EGG-NTA-8030  
Rev. 1

TECHNICAL EVALUATION REPORT  
TMI ACTION--NUREG-0737 (II.D.1)  
POINT BEACH, UNITS 1 AND 2  
DOCKET NOS. 50-266 AND 50-301

December 1988

Figure 4.3.1-1 Crosby 3K6 valve stem position in Test 506.

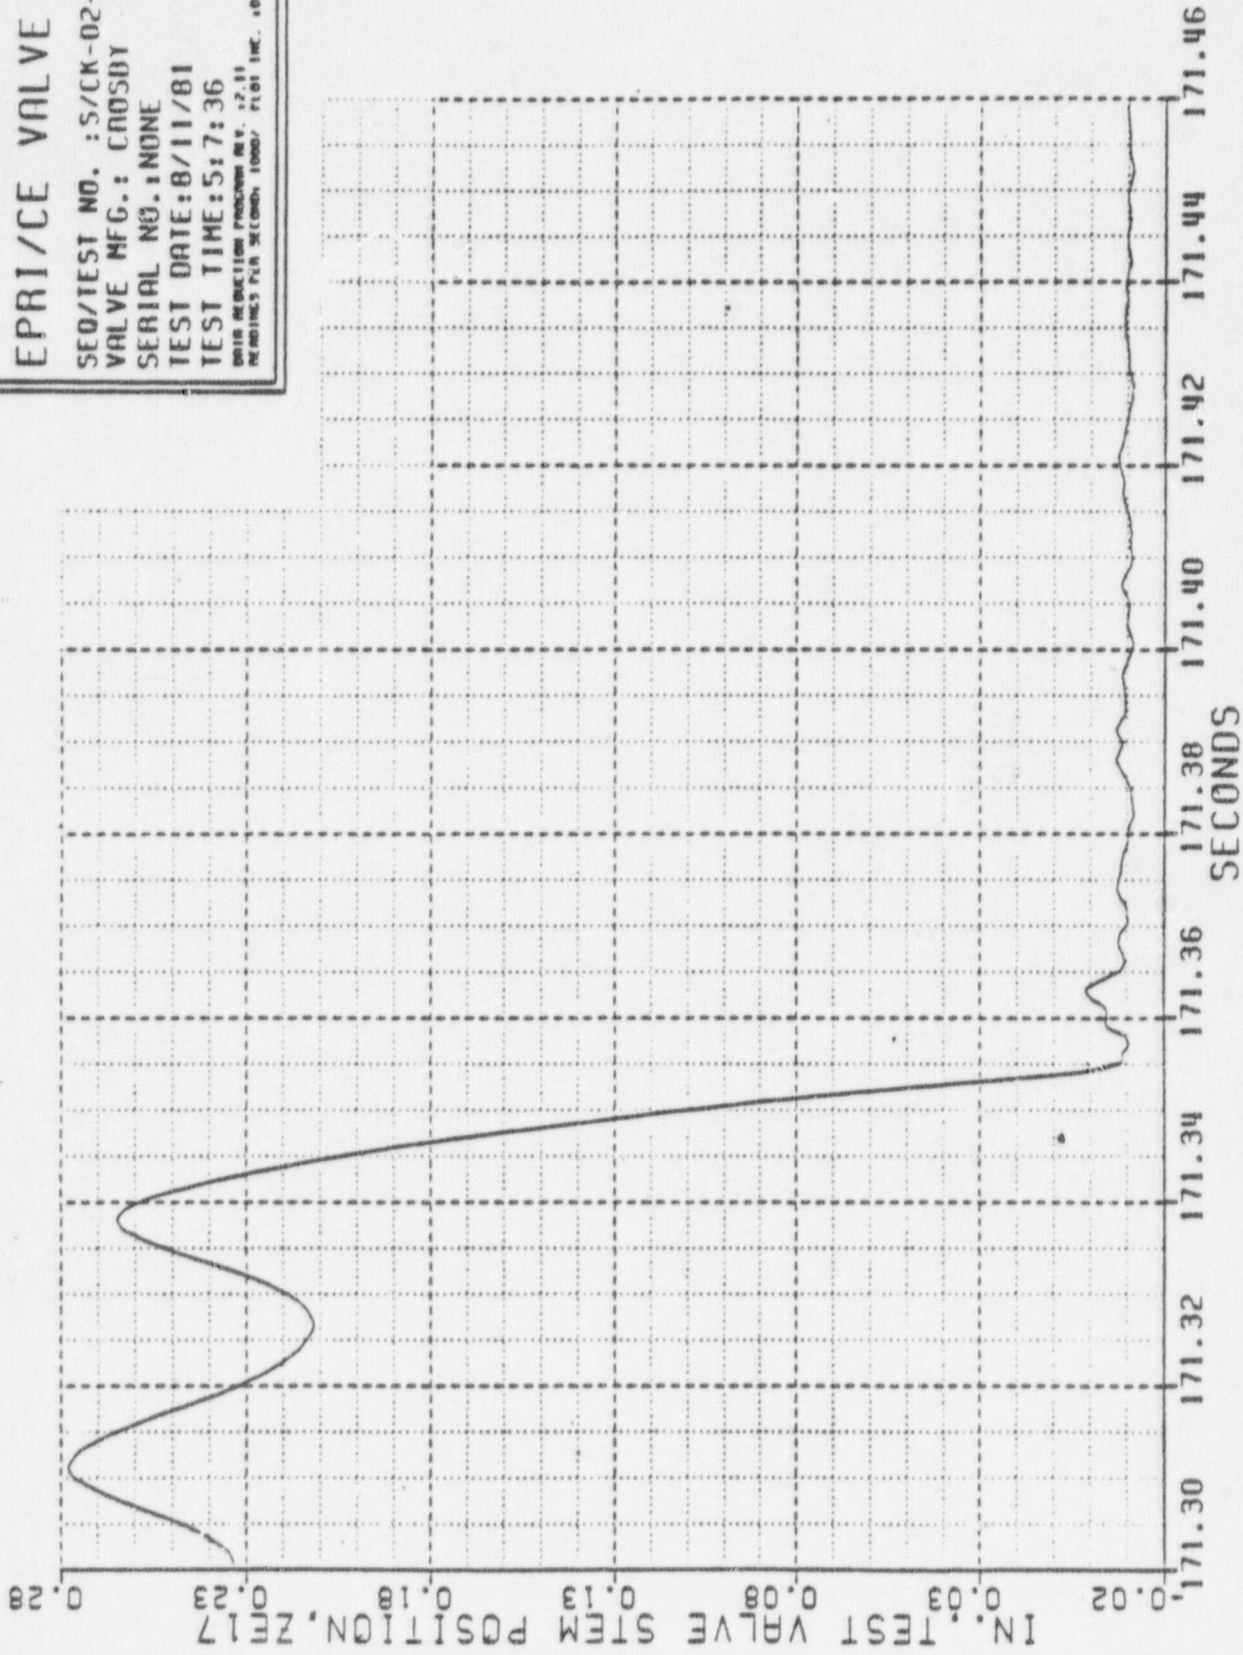
The situation with these two 3K6 tests is similar to the two 6M6 tests discussed above. Prior to Test 506, the valve was refurbished. During the test the valve, although it fluttered on closing, did not chatter and was able to close without operator intervention. Before Test 508, only the setpoint pressure was adjusted. According to the test report no internal parts were refurbished. In the test the valve chattered on closing and the operator manually terminated the test by opening the valve. These tests results reinforce the conclusion above that the Licensee should inspect the safety valves after each lift involving loop seal or water discharge to ensure proper operation during subsequent operation.
